Technical Service Bulletin

Topic	55 Tail light collides with rear lid, paint is coming off rear lid below tail light
Market area	United States 444 Volkswagen of America, Inc. (6444)
Brand	Audi
Transaction No.	2071125/2
Level	EH
Status	Released for publishing
Release date	Mar 10, 2025

Figure 1. Taillight chafing against the paintwork on the rear lid.

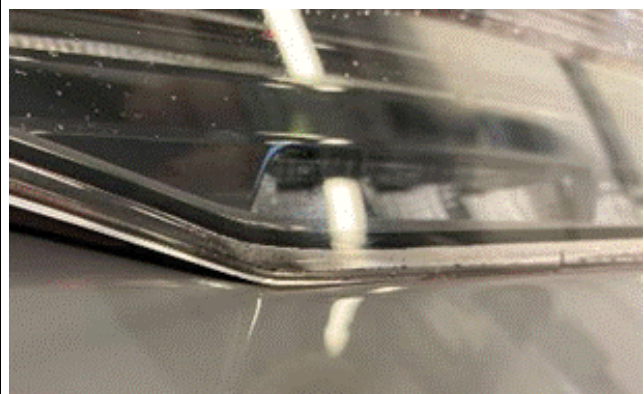
The gap between the taillight and rear lid is too small; this causes the taillight to chafe against the paintwork on the rear lid (refer to Figure 1).

Figure 4. *Buffer foam in their new position.*

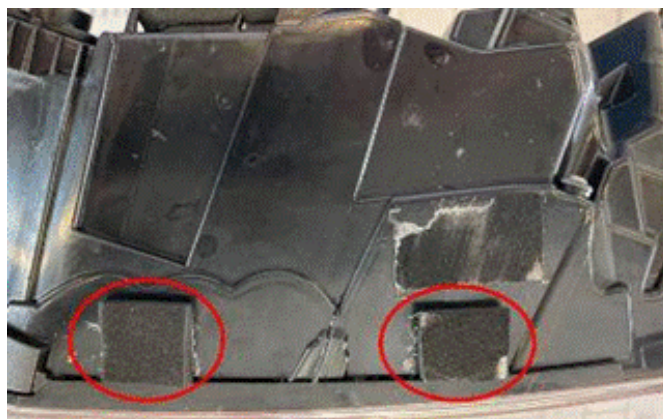
2. Cut the old buffer foam into two pieces and secure these in their new position with double-sided adhesive tape, e.g. AKL 440 02 (refer to Figure 4).
